Peer Review Panel Report on Findings Review of Three Operations Studies for the Design of the Caltrain Downtown Extension (DTX)

for: San Francisco County Transportation Authority (SFCTA)

PEER REVIEW PANEL
REPORT ON FINDINGS
REVIEW OF THREE OPERATIONS STUDIES FOR THE DESIGN OF THE CALTRAIN
DOWNTOWN EXTENSION (DTX)

Figure 1

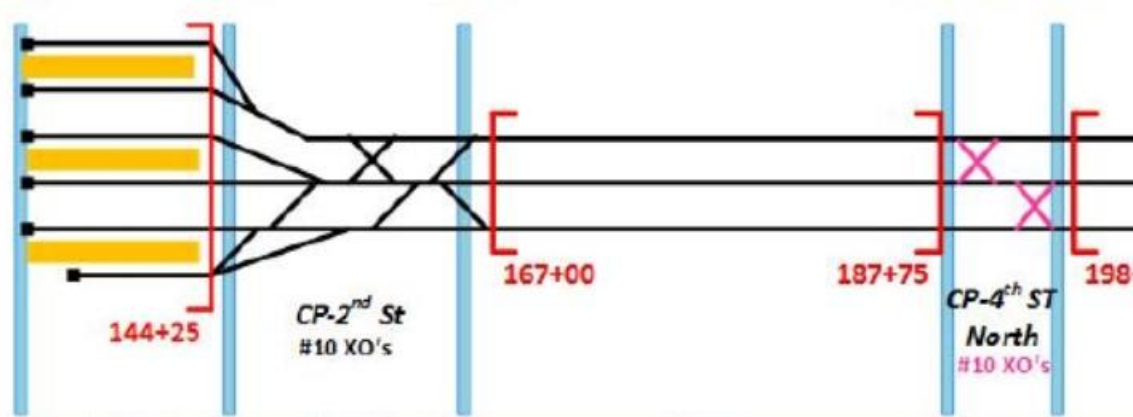
The peer review panel recognizes that the track alignment reflected in the Parsons study (Figure 1), including switch locations, has been reviewed and agreed to by Caltrain and CHSRA and has been signed off by FRA. This alignment is understood to reflect the current operational thinking of CHSRA and Caltrain, and considers the ventilation zones established for fire safety.

It is also understood that the alignment is a Preliminary Engineering concept (15% design), so adjustments can be expected as the plans are finalized to reflect operating plans and the resolution of the dedicated platforms question. At this stage in project development, the peer review panel recommends that the configuration of switches and crossovers at the throat of the STC be finally established based on the resolution of these parameters.

Figure 1 shows the base track configuration of the throat of the terminal as modeled by the Parson's team in the fall of 2017.

Figure 2

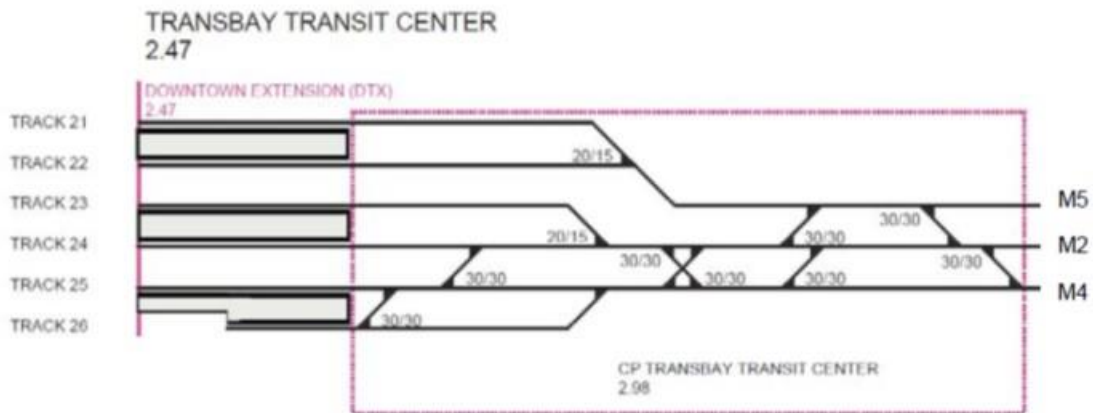
Figure 2 shows the base track configuration of the throat of the STC as depicted by the RAB report team in the Spring of 2017. It calls for one interlocking and seems to support high turnover on station tracks 24, 25 and 26. Tracks 21 and 22 appear to be designed for a much lower level of traffic with movements to or from either track blocking access to the other.

The two diagrams are clearly very different. Access to and from the low numbered station tracks is improved in the approved Parsons layout.
